Service Bulletin

NO. 348

Studebaker and Packard

REVIEW OF ENGINE OIL RECOMMENDATIONS

Fig. 3

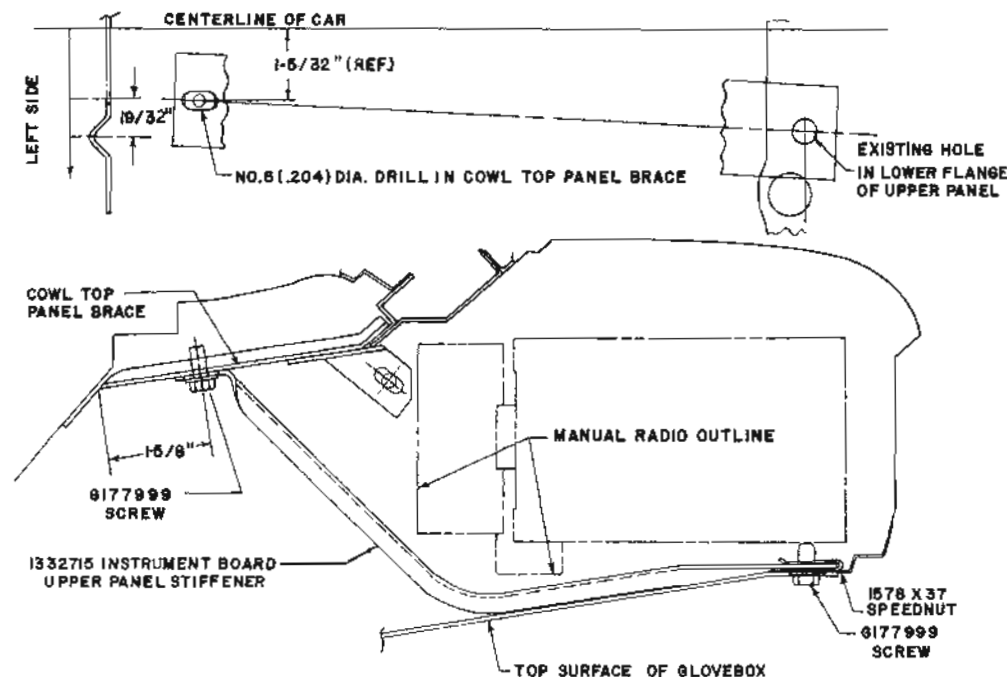
To provide increased stability of the instrument board panel, a stiffener brace entered production starting with Serial Nos. 59S-80105 and 59V-30318.

The brace, installed as shown in Fig. 3, may easily be installed in cars before the above serial numbers. The brace will reduce instrument board movement and assist in preventing squeaks, buzzes and rattles caused by excessive instrument board movement.

- 1 1332715 Instrument Board Upper Panel Stiffener Brace
- 2 G177999 Screw
- 1 1578X37 Speednut

To install, first remove the glove compartment box. It is not necessary to remove the radio in cars so equipped. Place the flat end of the brace on the upper opening flange for the glove box at the first hole to the left of the door catch and install the Screw, Part No. G177999, and Speednut, Part No. 1578X37. Using the brace as a template or the dimensions given in Fig. 3, mark and drill a 3/16" hole in the cowl top panel brace and install Screw, Part No. G177999. Install the glove compartment box.

FIG. 4

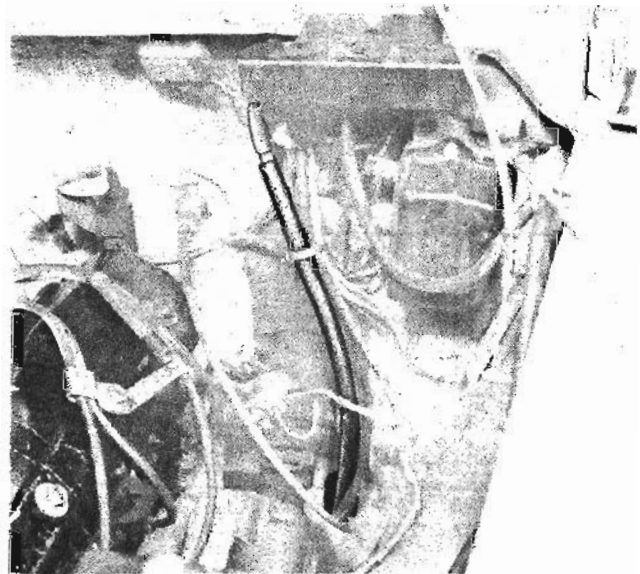
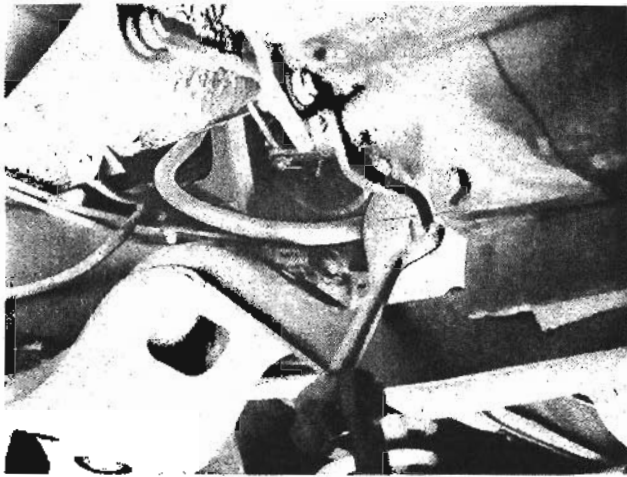
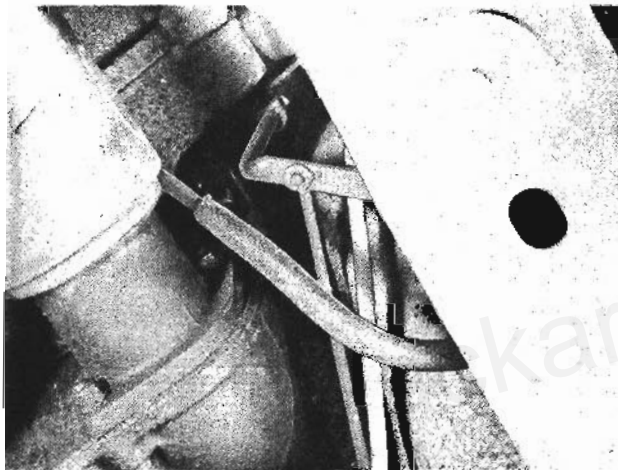
To prevent possible interference between the starter motor cable and the accelerator linkage, the starter switch-to-starter motor cable has been lengthened and rerouted on 59V Lark Models. This change entered production with Serial No. 59V-26047.

The improved routing of the cable is shown in Figure 4, 5 and 6.

The longer cable carries part number 1539935 and is carried in Parts Depot stock. This is the same cable as used on the 59V Hawk model from the start of production.

Note cable routed through
body hold-down bracket

FIG. 7

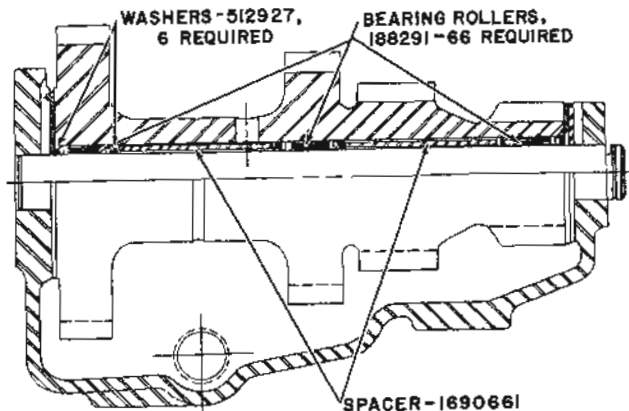
Beginning with the following serial numbers, a center bearing has been added to the countershaft of the T90B transmission.

This improvement can be incorporated in transmission of trucks having serial numbers prior to those listed above. Remove the long spacer and install two short Bearing Spacers, Part No. 1690661 with 22 additional bearing rollers, Part No. 188291, and two washers, Part No. 512927, between the two spacers in the center of the countershaft. See Fig. 7.

As an alternate, you may cut the long spacer into two sections 2.079" (2-5/64") long and then install the necessary additional bearings and washers.
